Access Compliance Report

Public Rights-of-Way

Intersection ID: 43653	Main Street: HUNTINGTON_MEADOW_LN	Cross Street: TAGGERT_TRAIL_DR	Location: NE
ADA ID: 70810EF52A96	Ramp Type: Perp	Initial Pass/Fail: Fail	Overall Compliance: No
		Severity Score: 12.5

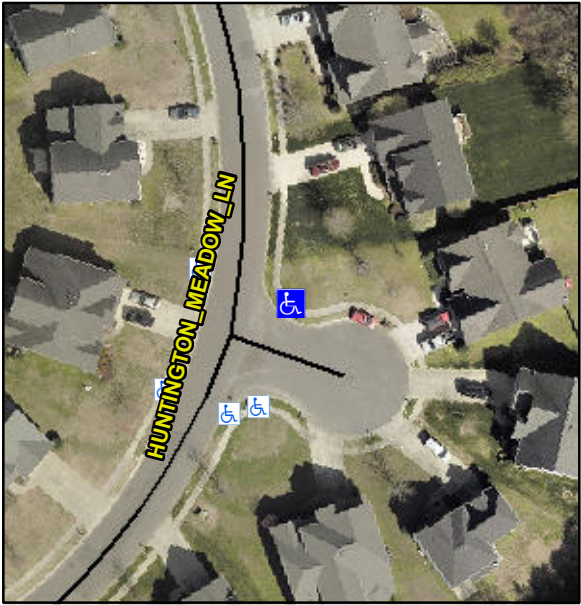
Codes/Mitigation Info/Possible Solution			Field Measurements/Component Compliance		
	Possible Solutions:		Compliance	Description	Data
	Remove & Replace Entire Ramp.		No	Ramp Length (in)	42.0
			Yes	Ramp Width (in)	49.0
			N/A	Flare Type LT	N/A
			N/A	Flare Slope LT (%)	N/A
			N/A	Flare Traversable LT?	N/A
			N/A	Landing Length (in)	N/A
			N/A	Landing Width (in)	N/A
			N/A	Landing Slope (%)	N/A
			N/A	Landing X Slope (%)	N/A
<p>Surveyor Notes:</p> <p>N/A</p> <p>PROW/ADA:</p> <p>Not Found, R304.2.2</p>			N/A	Flare Type RT	N/A
			N/A	Flare Slope RT (%)	N/A
			N/A	Flare Traversable RT?	N/A
			N/A	DWS Provided?	N/A
			N/A	DWS Contrast?	N/A
			N/A	DWS Length (in)	N/A
			N/A	DWS Full Width?	N/A
			N/A	DWS Offset (in)	N/A
			N/A	Shared Landing?	N/A
			N/A	Gutter Ponding?	N/A
			N/A	Gutter Lip Ht (in)	N/A
			N/A	Painted X Walk1?	No
				X Walk 1 Direction	To S
			N/A	X Walk 1 Width (in)	N/A
				X Walk 1 Slope (%)	1.9
				X Walk 1 X Slope (%)	1.2

N/A	Ramp inside XWalk1?	N/A
			N/A	Road Slope (%)	N/A
			N/A	Road X Slope (%)	N/A
			N/A	Any Obstructions?	N/A
				Obstruction Type	
			N/A		
			N/A		
			N/A		
			N/A		
			N/A		
			N/A		
			N/A		
			N/A		
			N/A		
			Yes	Surface Condition? (G/P)	Good
